Bayside Brunswick Concept Plan (MP 05_0091), Brunswick Heads, Byron Shire Council, Exhibition of Environmental Assessment

Bayside Brunswick Concept Plan (MP 05_0091) Environmental Assessment (EA) Review

Attachment C: Project site, water licences and associated environmental layers for Bayside Brunswick Concept Plan (MP 05_0091).

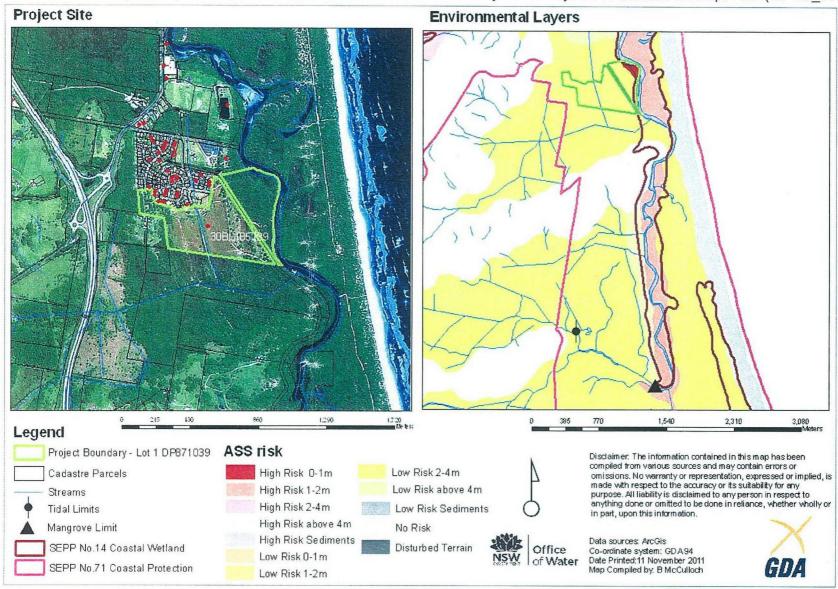
The concept plan (CP) is for a 178 residential subdivision comprising a mix of single dwelling, dual occupancy and medium density lots on Lot 1 DP871039 (project site) in the Byron Local Government Area. The CP will also include the provision of local parks and the dedication of an 8.2 Ha parcel of land adjacent to Simpsons Creek for the purpose of an environmental park. The western portion of the site is zoned Residential (2(a)) while the area to the east is Environmental Protection Coastal Habitat (7(b)) and to the north-east Environmental Protection Wetland (7(a)) under the Byron Local Environmental Plan 1988 (Byron LEP). The project site is covered by the State Environmental Planning Policy (SEPP) 71 Coastal Protection and part of the eastern boundary is under SEPP 14 Coastal Wetland (Attachment C).

The project site has permanent high water tables and the soils on the site are often waterlogged and have a low water-holding capacity with localised salinity (Morand, D.T. (1994). *Soil Landscapes of the Lismore-Ballina 1:100 000 Sheet* Map, Soil Conservation Service of NSW, Sydney). The Office of Water has identified an acid sulphate soil (ASS) risk at 2–4 m for most of the land covering the project site with the exception of an area in the north-eastern portion of the site which is high ASS risk 0-1 m (Attachment C).

An existing bore licence currently exist on the site (30BL185289) which authorises three wells (bores) for monitoring purposes in the name of the applicant Codlea Pty Ltd (Attachment C). In s.3.1 (pg 3) of the Surface & Groundwater Assessment (SGA) prepared by Waste Solutions Australia Pty Ltd, it is stated that three bore have been constructed at sites in Figure 2 in Appendix A. The Office of Water databases show that *Form A* (geological core logs) relating to the bores have not been forwarded to the Water Licensing Branch in either Murwillumbah or Grafton. The Applicant must forward to Office of Water the locality and details of the bores on a *Form A* to the Office of Water Licensing Branch at either the Murwillumbah or Grafton office as required in condition 2 of the licence (30BL185289). All the details which are required in completing the *Form A* are located at http://www.water.nsw.gov.au/Water-licensing/Applications/default.aspx.
